SUBJECT: Response to Request for Additional Information – License Amendment Request – Replacement of Spent Fuel Pool Region I Storage Racks

Palisades Nuclear Plant
Docket 50-255
License No. DPR-20

**ATTACHMENT 1
RESPONSE TO REQUEST FOR ADDITIONAL INFORMATION
REGARDING LICENSE AMENDMENT REQUEST
FOR REPLACEMENT OF SPENT FUEL POOL REGION 1 STORAGE RACKS**

Figure RAI- 20-1 LS-DYNA Model of 12 x 12 Sizewell Rack

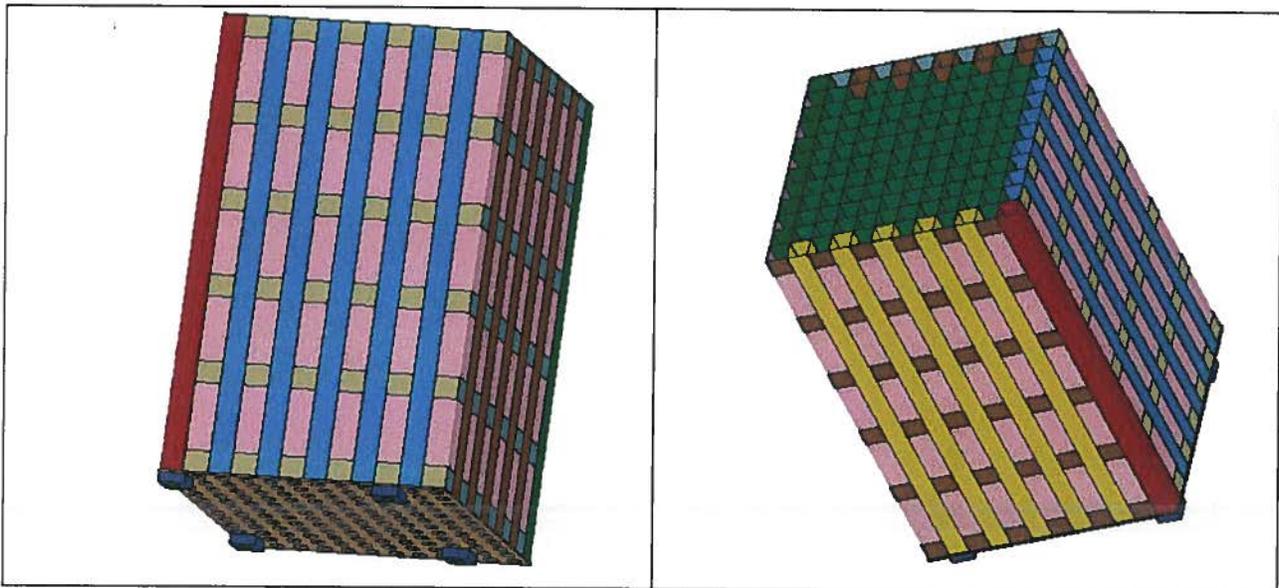
6. *Figure 6.4.1 of Attachment 6 to the LAR submittal depicts the model used for DYNARACK time history analyses. Please state whether the DYNARACK model has been previously benchmarked against other numerical analysis methods, namely methods which employ a more explicit method of analysis (e.g., commercial finite element analysis software). Additionally, state whether the Palisades-specific acceleration time histories were used to benchmark the DYNARACK time history analyses.*

6. The DYNARACK model has been previously benchmarked against a three-dimensional finite element model created in LS-DYNA, a commercial finite element analysis code. This benchmark work is described in a previous RAI response related to the LAR submittal for the Beaver Valley Unit 2 rack replacement (FirstEnergy letter to the NRC dated May 21, 2010, Docket No. 50-412, number L-10-151, ADAMS Accession number ML101460057), which is reproduced below in its entirety. PNP-specific acceleration time histories were not used to benchmark the DYNARACK time history analyses. The benchmark work described below adequately demonstrates the capability of the DYNARACK model to conservatively predict the seismic response of an HCC SFP rack.

In 2008, Holtec developed a detailed finite element model of a 12 x 12 PWR spent fuel rack (Reference 6) for Sizewell nuclear plant. This nuclear power plant is located in England and operated by British Energy. The model, which is shown below in the Figure RAI-20-1, was built using LS-DYNA.

As shown in the figure above, all load bearing components of the spent fuel rack, including the support pedestals, the base plate, the cell walls, and the weld connections, were modeled explicitly using a combination of thick shell, shell, and solid elements. In addition to the rack structural components, the stored fuel assemblies were individually modeled in LS-DYNA as separate bodies and positioned within every storage cell location. Appropriate contact interfaces were defined between the cell walls, the base plate, and the fuel assemblies to allow each fuel assembly to rattle freely inside its storage cell under the applied loading. The entire model included nearly 200,000 elements.
